Back Box and Putty Pad fixing detail

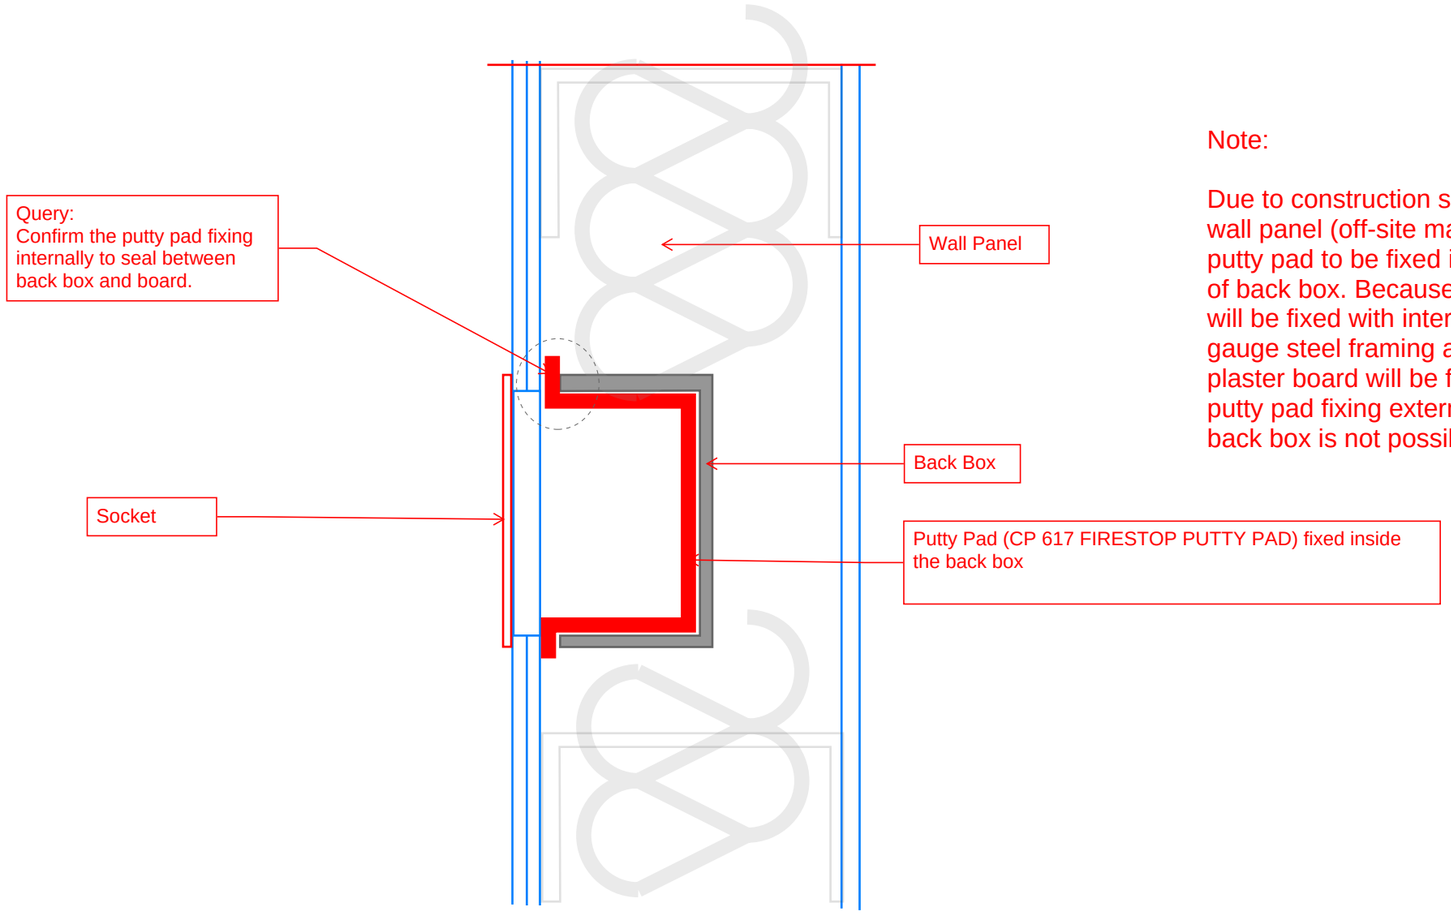
Due to construction sequence of wall panel (off-site manufactured) putty pad to be fixed internal side of back box. Because Back box will be fixed with internal Light gauge steel framing and after that plaster board will be fixed, hence putty pad fixing external side of back box is not possible.
